Service Provider Letter

13-002298

Jurisdiction: City of Sherwood **Review Type:** No Impact

Site Address / Location: 14816 SW Century DR
Sherwood, OR 97140 **SPL Issue Date:** September 26, 2013
SPL Expiration Date: September 26, 2015

SHEET TITLE:
EXHIBIT 1
WETLANDS

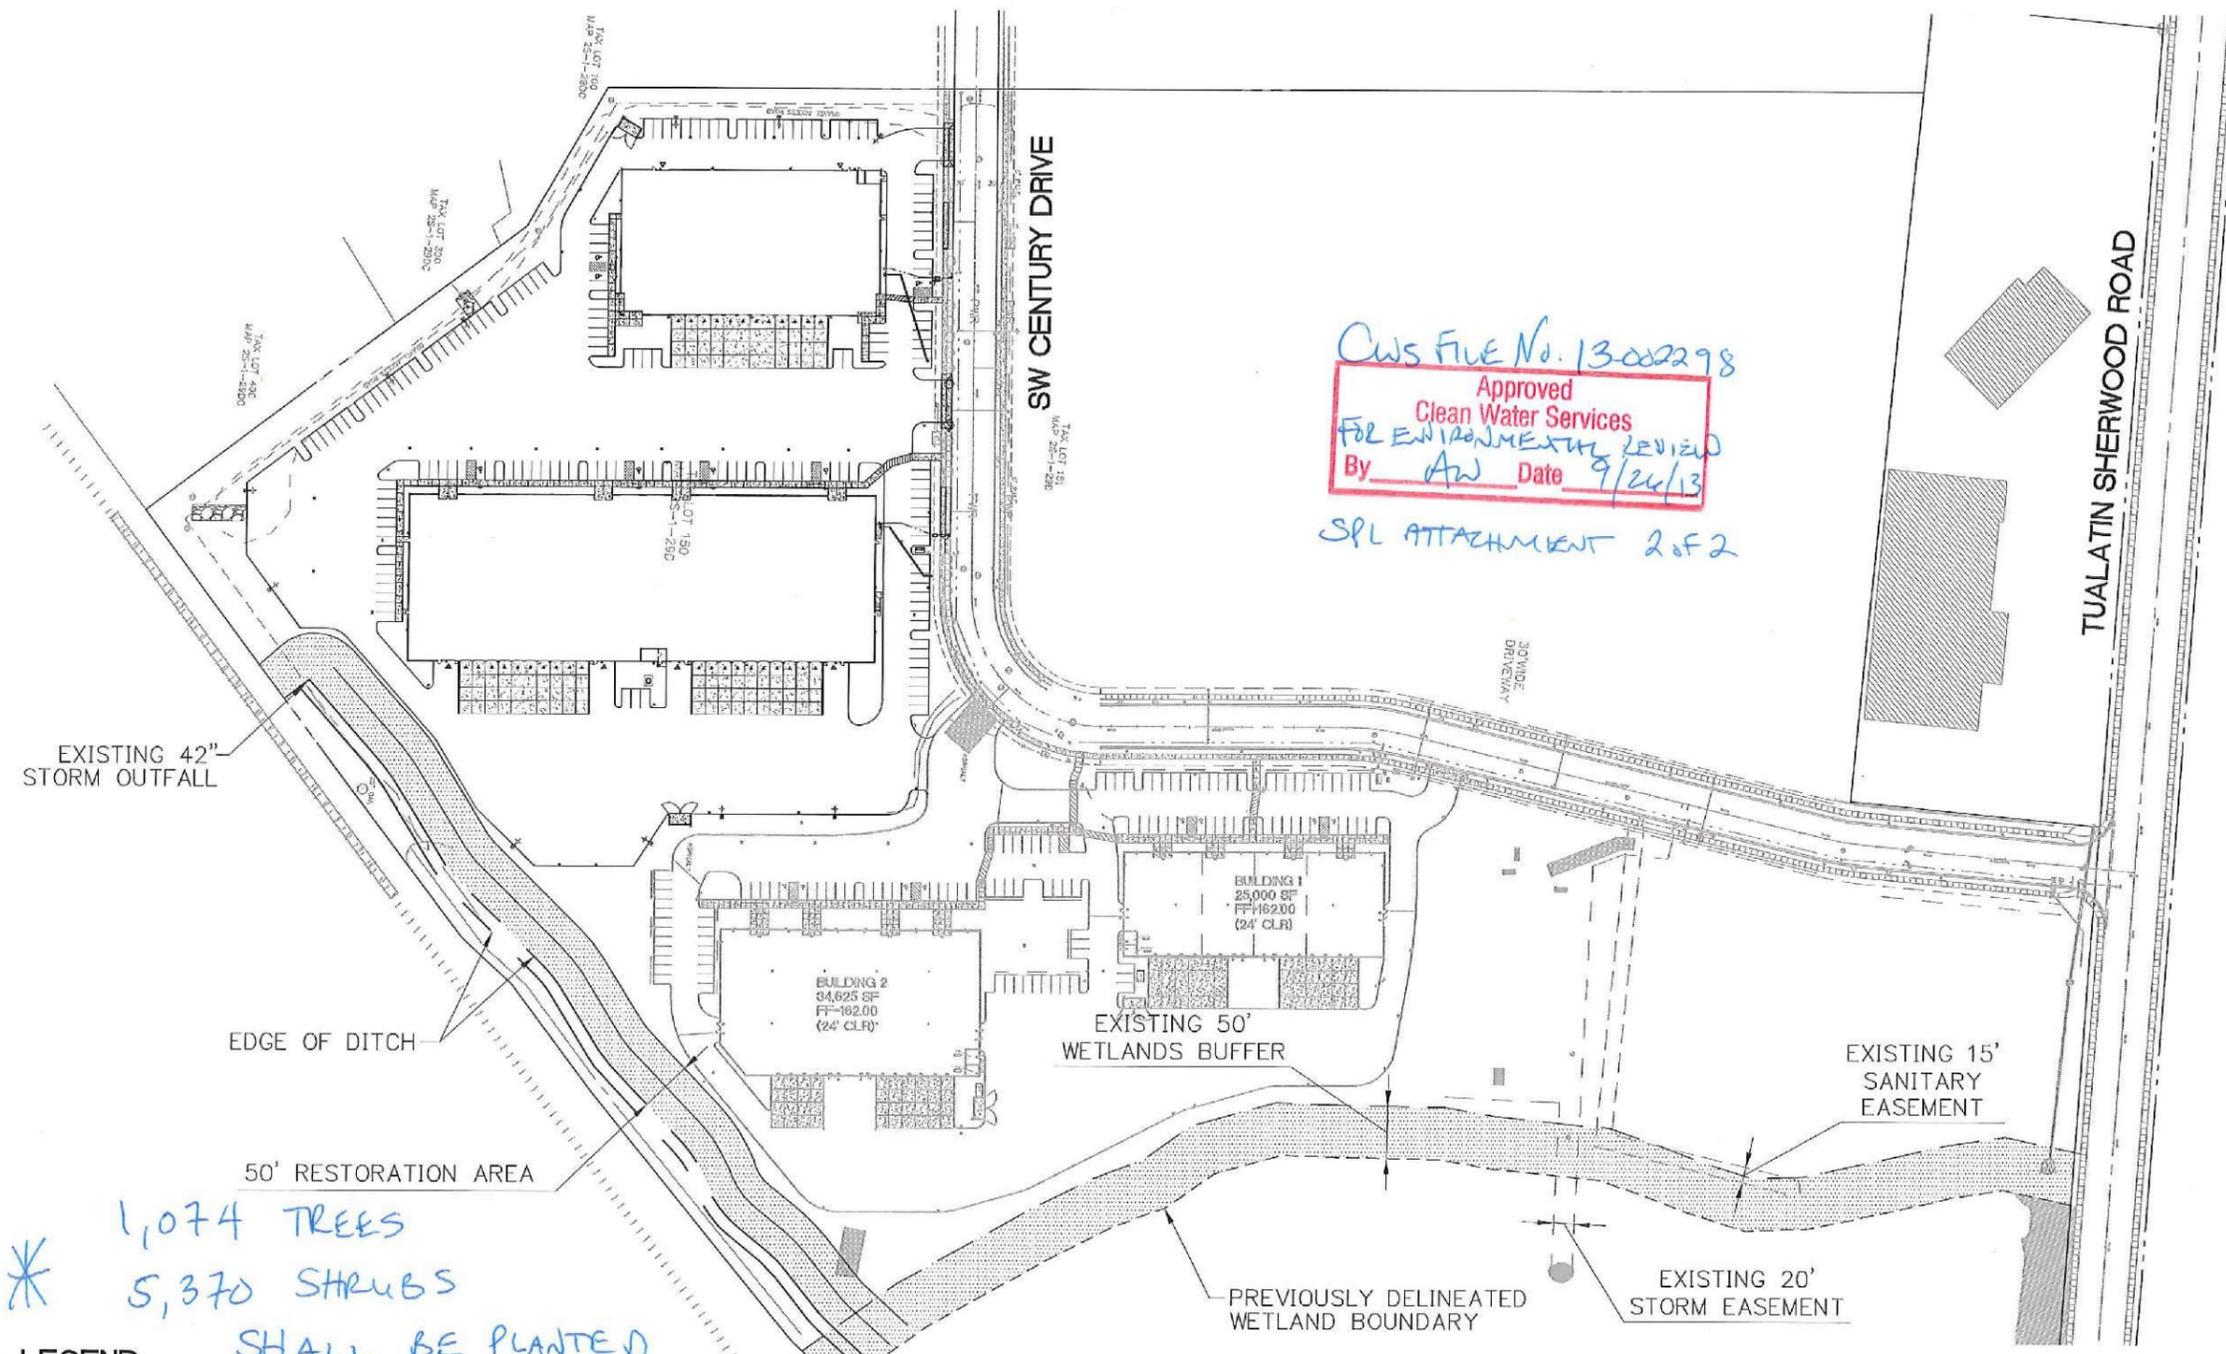
1,074 TREES
5,370 SHRUBS
SHALL BE PLANTED
CONCURRENT
WITH DEVELOPMENT

EXISTING 50' WETLAND
BUFFER/RESTORATION AREA
TOTAL AREA = 107,395 SF
= 2.46 AC
